**Report By:**

**Report: Issue Data**  
**Function: Test, Adjust, & Balance**  
**Date: 12/04/2025**  
**Completed By: National TAB**

**PROJECT**  
**CW 8950 - Mr Cooper (Coppell, TX)**

Project: CW 8950 - Mr Cooper (Coppell, TX)

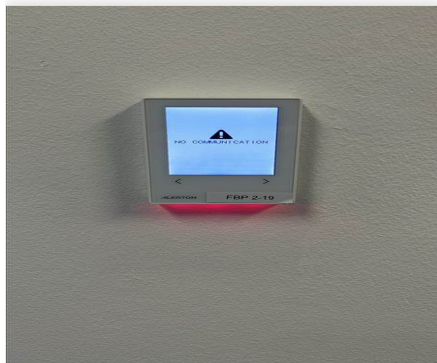
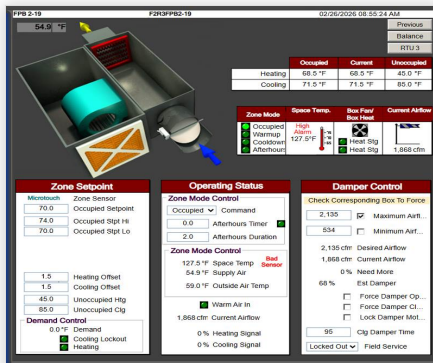
**Issue Name :** FPB-E2-A3 (CONTROLS NAME: FPB2-19) Bad Thermostat  
**Description :** FPB-E2-A3(Controls Label FPB2-19) thermostat is showing "No Communication" and is reading a space temperature of 130 degrees. This is not allowing the FPB to go into heat mode and is keeping us from balancing the fan of this FPB.

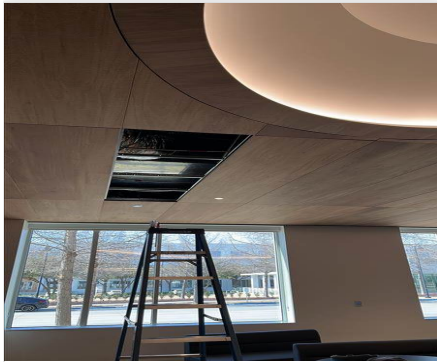
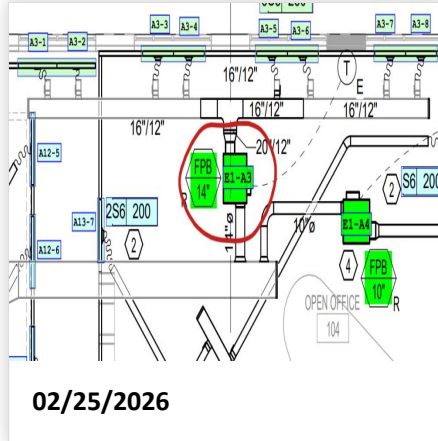
**Issue Name :** FPBE1-A3 (CONTROLS NAME: FOB1-22) Fan Not Operational  
**Description :** Existing FPBE1-A3 fan is not operational. Controls name for this FPB is FPB 1-22.  
**Created By :** National TAB                      **Assigned To :** National TAB - Stephan Gabbert  
**Status :** Open  
**Priority :** **Urgent**                                      **Asset Tag :**  
**Originated Date :** 02/25/2026 - Bayley Morvant - National TAB

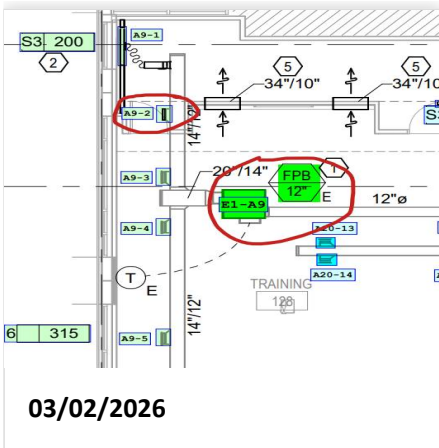
**Issue Name :** FPBE1-A9 Missing Diffuser  
**Description :** FPBE1-A9 is missing diffuser #2 as shown on drawings. Diffuser is shown to serve above doorway going from Training 128 to the corridor.  
**Created By :** National TAB                      **Assigned To :** National TAB - Stephan Gabbert  
**Status :** Open  
**Priority :** **Urgent**                                      **Asset Tag :**  
**Originated Date :** 03/02/2026 - Bayley Morvant - National TAB

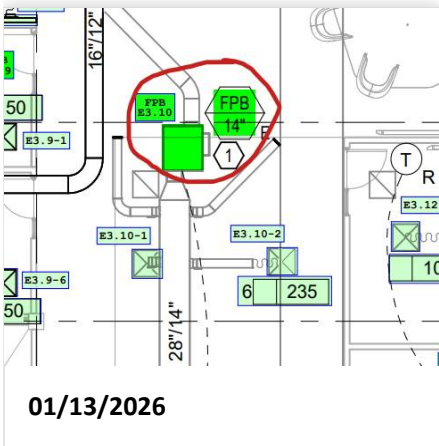
**Issue Name :** FPBE3-10 (CONTROLS NAME: FPB3-38) Fan Not Operational  
**Description :** Fan not operational during time of testing. Unit is an existing box. (controls label is FPB3-38) Fan not operational as of 2/25/2026  
**Created By :** National TAB **Assigned To :** National TAB - Stephan Gabbert  
**Status :** Open  
**Priority :** Urgent **Asset Tag :**  
**Originated Date :** 01/13/2026 - Bayley Morvant - National TAB

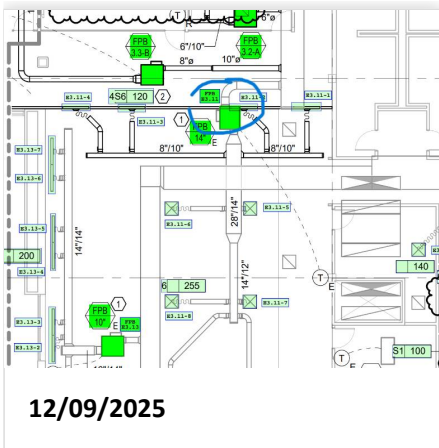
**Issue Name :** FPBE3-11 (CONTROLS NAME: FPB3-51) Fan Not Operational  
**Description :** FPB3E3-11 fan is not operational. Unit is an existing box. (Controls label is FPB3-51) Fan not operational as of 2-25-2026  
**Created By :** National TAB                      **Assigned To :** National TAB - Stephan Gabbert  
**Status :** Open  
**Priority :** **Urgent**                                      **Asset Tag :**  
**Originated Date :** 12/09/2025 - Bayley Morvant - National TAB

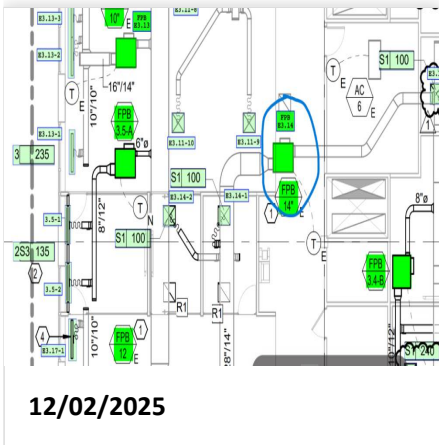
**Issue Name :** FPBE3.14 (CONTROLS NAME: FPB3-48) Fan not operational  
**Description :** Fan not operational during time of testing. Unit is existing box. (box labeled as FPB3-48 on controls graphics) Fan not operational as of 2-25-2026  
**Created By :** National TAB **Assigned To :** National TAB - Stephan Gabbert  
**Status :** Open  
**Priority :** Urgent **Asset Tag :**  
**Originated Date :** 12/02/2025 - Bayley Morvant - National TAB

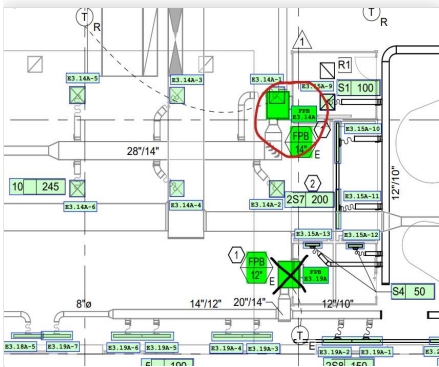
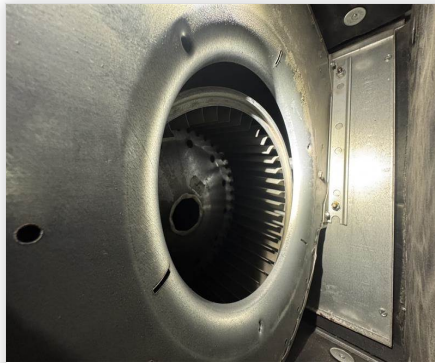
**Issue Name :** FPBE3.14A (CONTROLS NAME: FPB3-06) Fan Not Operational  
**Description :** Fan not operational during time of testing. Unit is existing box. (box labeled as FPB3-06 on controls graphics) Fan not operational as of 2/25/2026. Fan wheel is not attached to motor. See pictures  
**Created By :** National TAB                      **Assigned To :** National TAB - Stephan Gabbert  
**Status :** Open  
**Priority :** Urgent                                      **Asset Tag :**  
**Originated Date :** 01/27/2026 - Bayley Morvant - National TAB

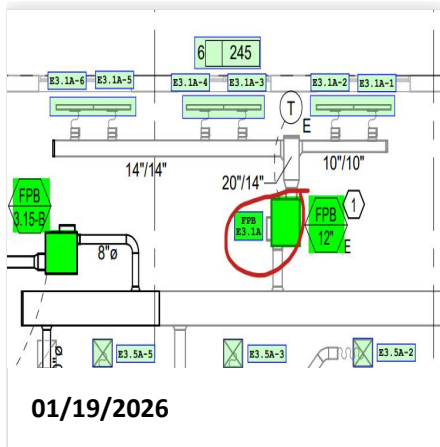
**Issue Name :** FPBE3.1A (CONTROLS NAME: FPB3-18) Fan Not Operational  
**Description :** Unit fan not operational in heating mode. Unable to balance fan to design. Unit is an existing unit. (Controls label is FPB3-18)Fan not operational as of 02/25/2026  
**Created By :** National TAB                      **Assigned To :** National TAB - Stephan Gabbert  
**Status :** Open  
**Priority :** Urgent                                      **Asset Tag :**  
**Originated Date :** 01/19/2026 - Bayley Morvant - National TAB

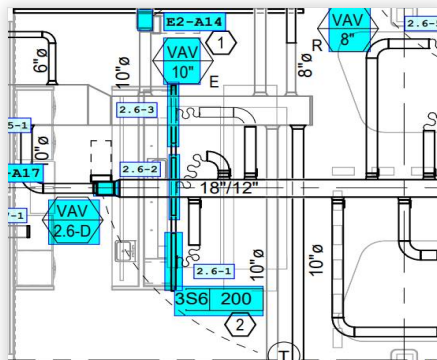
**Issue Name :** VAV 2.6-D (CONTROLS NAME: VAV2-50) Primary Air Damper Issue  
**Description :** VAV2.6-D is not controlling correctly. No matter what overrides are put into controls or what the controls is telling the VAV to do it is not operating. Damper stays at 100% open no matter what controls says the damper percentage is at. This will need to be fixed before this VAV can be calibrated and balanced. (Controls label is VAV2-50)

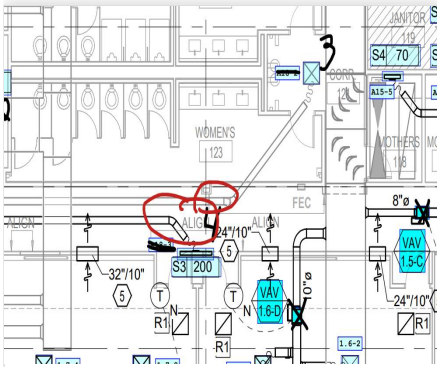
**Issue Name :** VAVE1-A11 (CONTROLS NAME: VAV1-19) Primary Air Damper Issue  
**Description :** VAVE1-A11 (VAV1-19 controls label) actuator is not following any overrides or operating correctly. Damper actuator stays in fully closed position no matter what overrides or setpoints controls is putting in. Unable to calibrate and balance VAV until this is fixed.

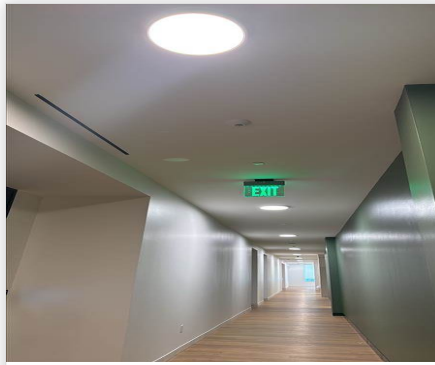
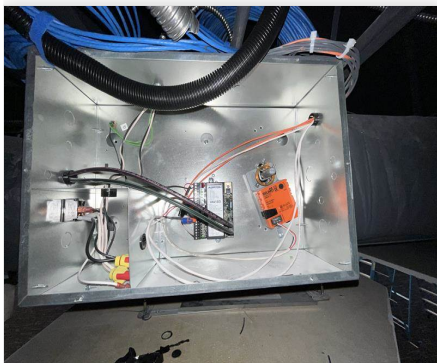
**Issue Name :** VAVE1-A18 No Access to Dampers  
**Description :** Diffusers #3 and 4 need access panel cut into sheet rock ceiling in Corridor 124 to access dampers for both diffusers. Brad with PBI is aware of this issue and is looking into a solution.  
**Created By :** National TAB                      **Assigned To :** National TAB - Stephan Gabbert  
**Status :** Open  
**Priority :** Urgent                                      **Asset Tag :**  
**Originated Date :** 03/04/2026 - Bayley Morvant - National TAB

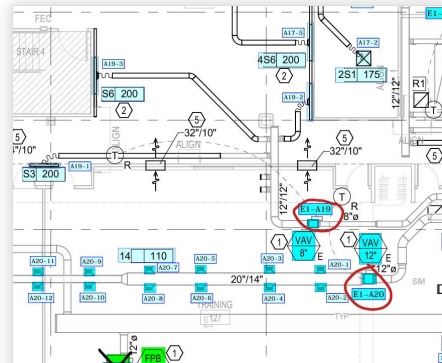
**Issue Name :** VAVE1-A19 No Power  
**Description :** VAVE1-A19 (Controls label is VAV1-11) is not operational. VAV does not have a transformer installed, so VAV controller has not yet been wired up for power.  
**Created By :** National TAB                      **Assigned To :** National TAB - Stephan Gabbert  
**Status :** Open  
**Priority :** Urgent                                      **Asset Tag :**  
**Originated Date :** 02/25/2026 - Bayley Morvant - National TAB

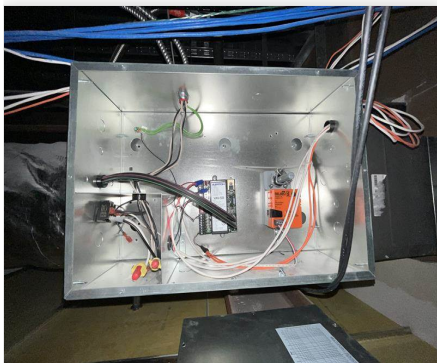
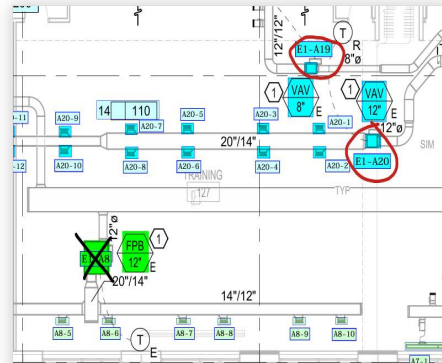
**Issue Name :** VAVE1-A20 No Power  
**Description :** VAVE1-A20 (Controls label is VAV1-10) is not operational. VAV does not have a transformer installed, so VAV controller has not yet been wired up for power.  
**Created By :** National TAB                      **Assigned To :** National TAB - Stephan Gabbert  
**Status :** Open  
**Priority :** Urgent                                      **Asset Tag :**  
**Originated Date :** 02/25/2026 - Bayley Morvant - National TAB
